**Subject: Hawks Nest Hydroelectric Project (FERC No. 2512)
Modernization Project – Non-Capacity Amendment Application**

Revised Exhibit A

Strikethrough and Final Versions

Revised Exhibit G Drawings

Figure 2-2. Project Area and Tree Clearing Area

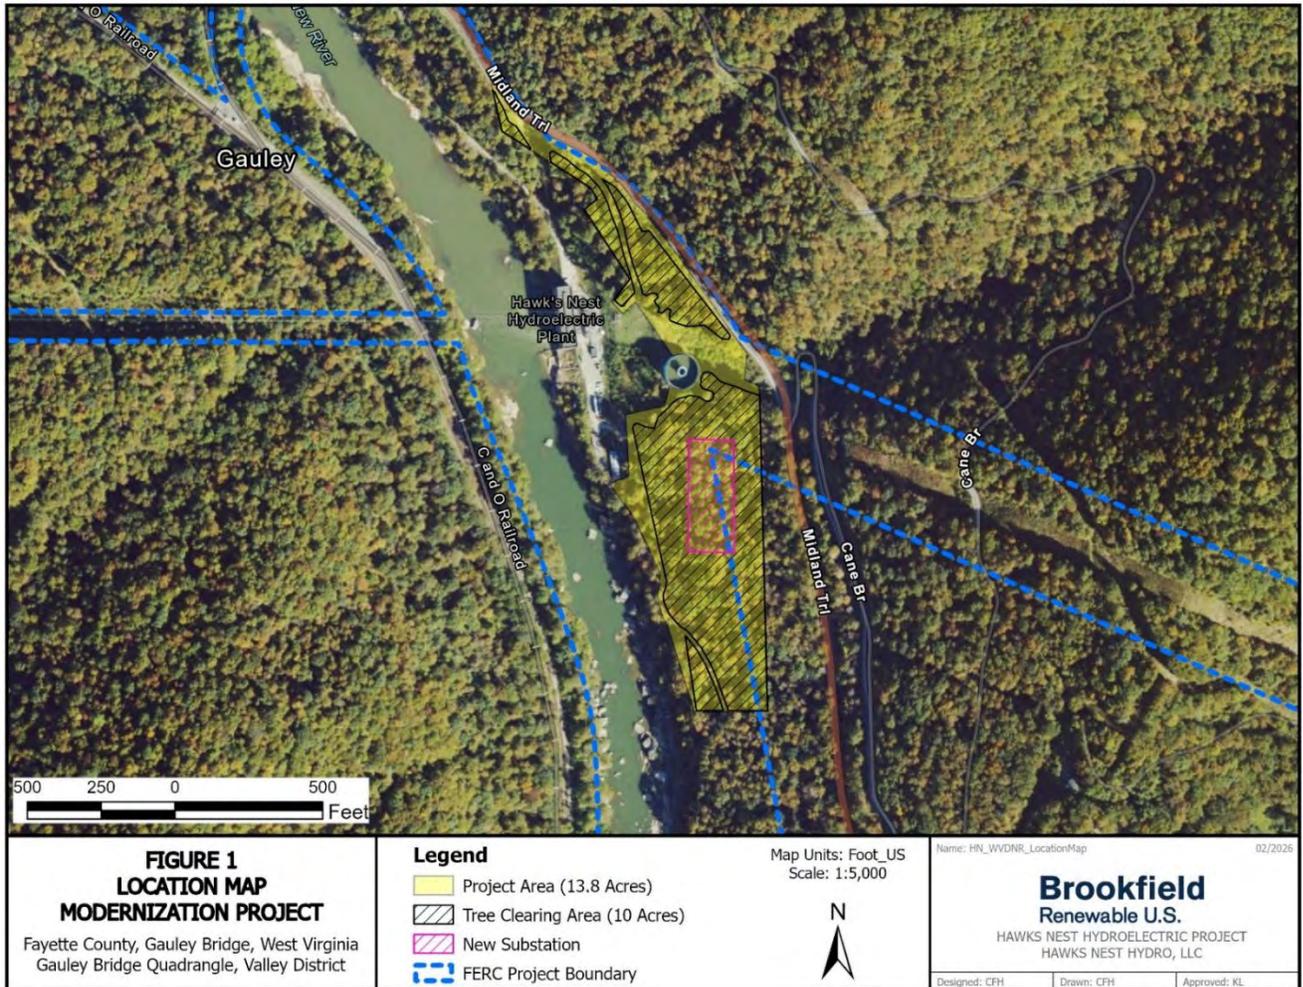
The HN FC Switchyard would be constructed southeast of the Project powerhouse (Figure 2-2). It would include a new 53MVA 13.8-kV 25Hz/13.8-kV 60Hz static FC enclosed within a 51-ft x 250-ft prefabricated metal building; two new approximately 500-foot [ft]-long 13.8-kV lines (generator leads) from the powerhouse to the HN FC Switchyard; a 0.7-acre temporary laydown area for use during construction; a turnaround area for delivery trucks, cranes, and other maintenance vehicles; an area for a mobile 150-ton crane near the locations of the transformers; crane pad in the vicinity of the existing surge basin approximately 60 ft by 40 ft in size; smaller pad areas and temporary access paths for the construction of new transmission line structures; and a new access road.

- Clearing of up to 10 acres of vegetation to facilitate construction of roadway and pad (Figure 2-2).
- Civil site works including cuts up to approximately 35 ft and fills up to 40 ft to establish final project grades for the new roadways and HN FC Switchyard pad.
- Construction of earth retention systems to support the proposed cuts and fills.
- Site flatwork improvements to include paved parking/turn around area, drainage aprons, and/or sidewalks, and deep foundations for HN FC Switchyard and ancillary structures.
- Establishment of new transmission right of way for the generator leads and installation of associated poles and transmission lines.
- New area drainage connecting to existing outlet.
- Modification to the existing Hawks Nest Switchyard to facilitate new interconnection.

Figure 2-3. Proposed Powerhouse Area Modifications

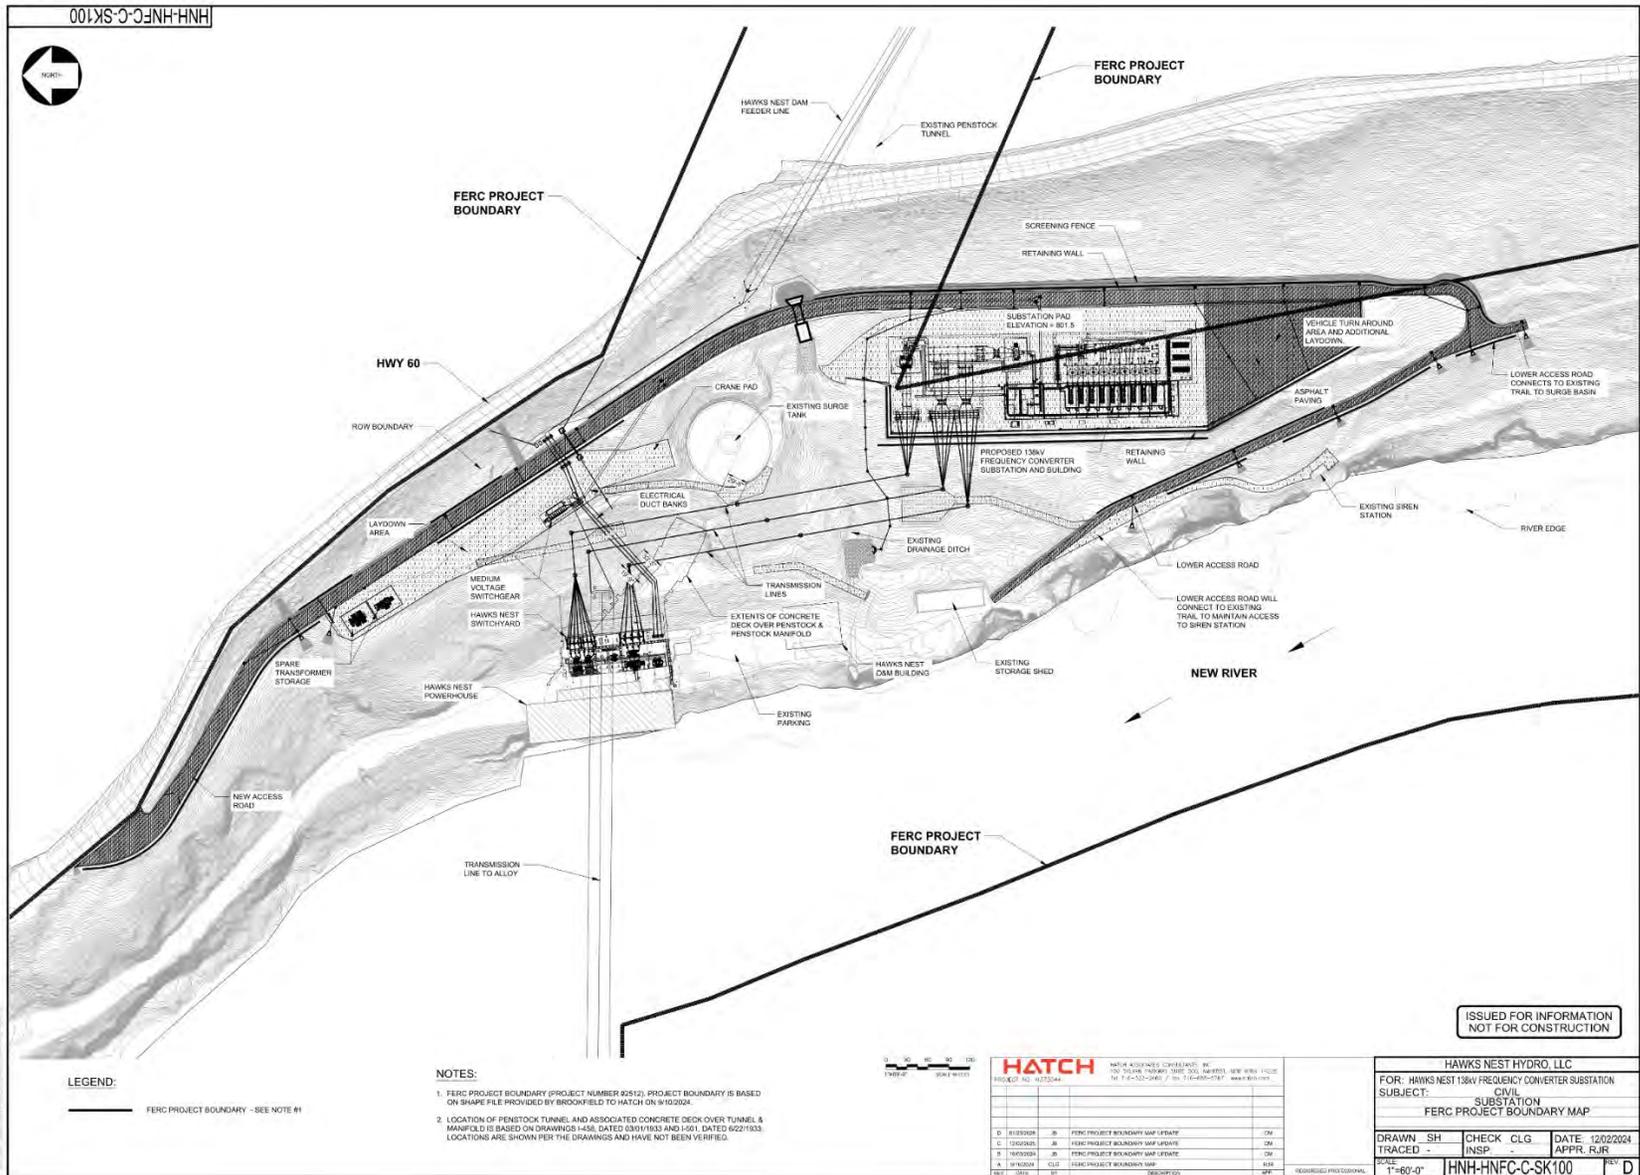
A new paved road would be needed for access to the HN FC Switchyard (Figure 2-3). The new access road would extend from Highway 60 to the HN FC Switchyard, including one crossing of the Project's underground water-conveyance tunnel. The road would be 20 ft wide with 2.5-ft shoulders on each side and a maximum 10 percent slope along the roadway. It would be constructed in a manner that minimizes stress on the Project underground water conveyance tunnel. Similarly, the Licensee would restrict the weight of vehicles using the road to limit potential effects to the tunnel. Hawks Nest Hydro will consult with the FERC Division of Dam Safety and Inspections-New York Regional Office regarding construction activities associated with the access road.

HAWKS NEST HYDROELECTRIC PROJECT
FERC No. P-2512
PROJECT BOUNDARY REVISION
EXPLANATION MAP

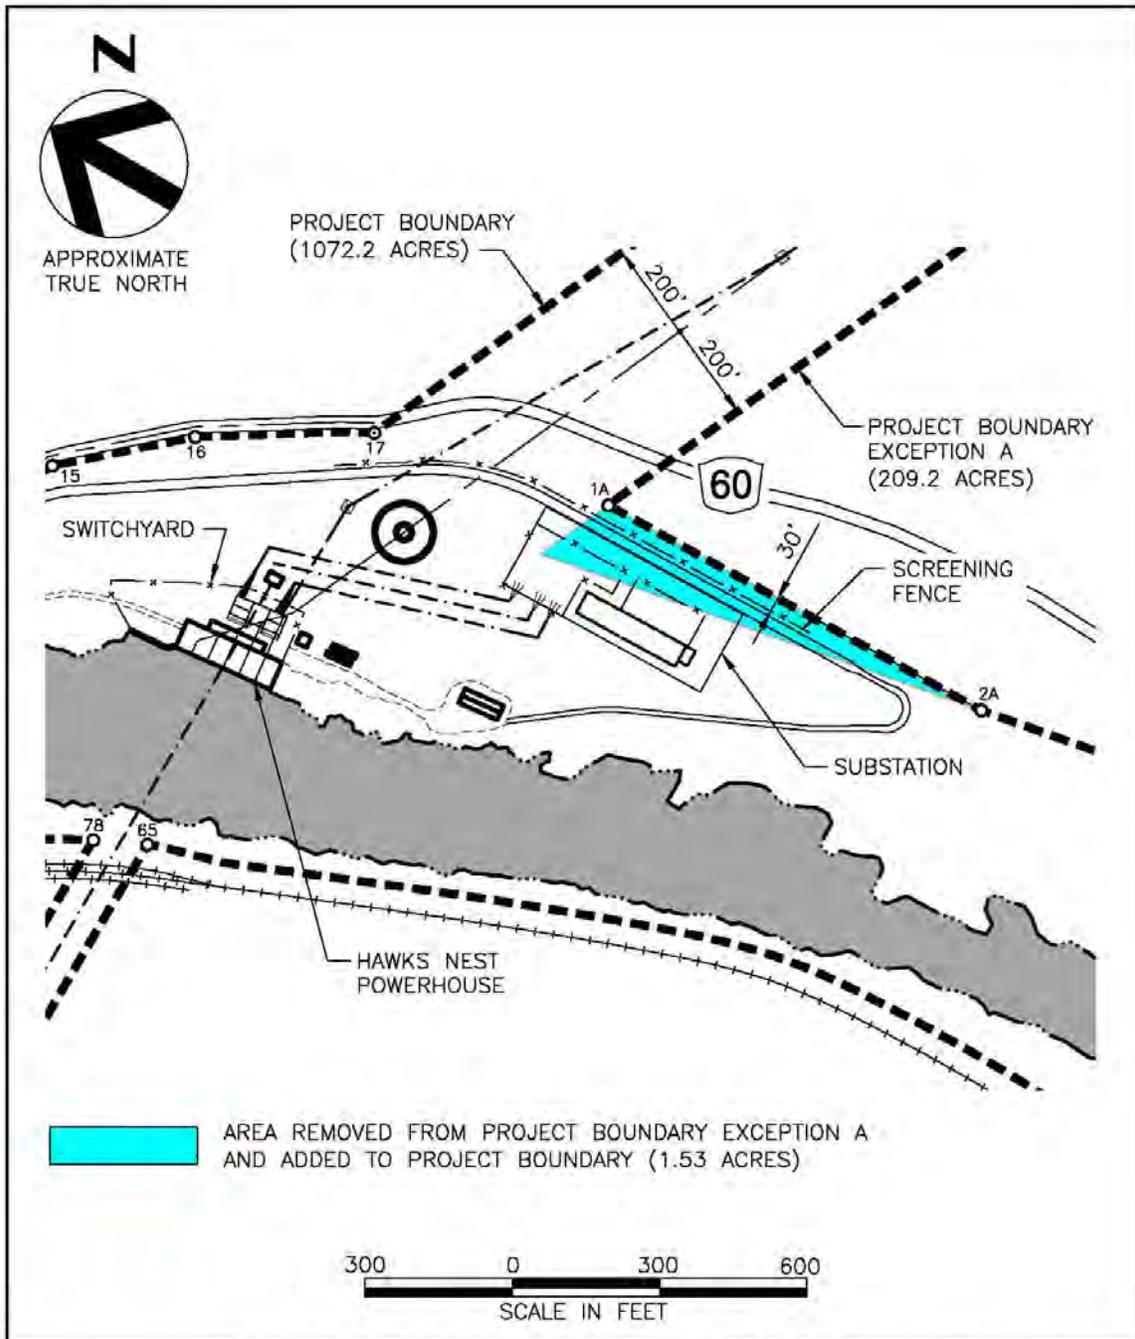
- Exhibit G: Project Maps (18 CFR 4.41(h)): Hawks Nest Hydro is providing revised Exhibit G drawings of the proposed Project boundary incorporating the proposed switchyard and access road. A drawing showing the current and proposed Project boundaries is also included in Exhibit G. (Attachment 3)
